1894_251015

DM/25/1123 - EASTLANDS FARMHOUSE MALTHOUSE LANE HURSTPIERPOINT HASSOCKS WEST SUSSEX BN6 9LA

Following the recent further drainage survey work, we can respond to the drainage engineers comments below:-

Section Pictures - 05/10/2025 - RWPX

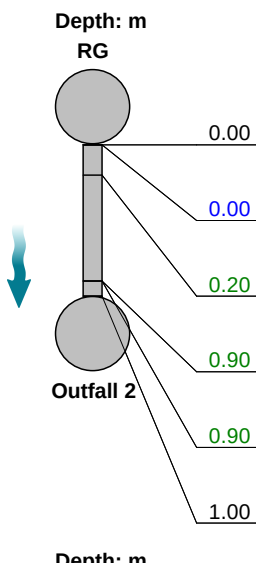
MSDC drainage engineer comment - Any outlets from the pond should be traced to a watercourse to demonstrate onward connectivity. Alternatively, a calculation showing the existing discharge rate through the outfall pipe into the pond should also be provided to evidence that site discharge would decrease post-development. If this existing discharge through the outfall pipe is greater than the proposed 1.8l/s then we would find the discharge rate acceptable. The greenfield site run off

SDA response – The outlet has been exposed and CCTV traced (report attached) to the pond showing the 100mm pipe from the rainwater pipe is not only severely blocked but damaged thus requiring renewal. The survey was also able to prove that the pond has an outlet. Regarding the flowrates from the site, the 1.8 lit/sec is restricted run off rate given as less than the 10 year greenfield rate for the site boundary (see attached, the 30, & 100 year indicate 4.2 and 5.8 l/s greenfield rates). We have attached our GA drawing revised to suit the recent surveys.
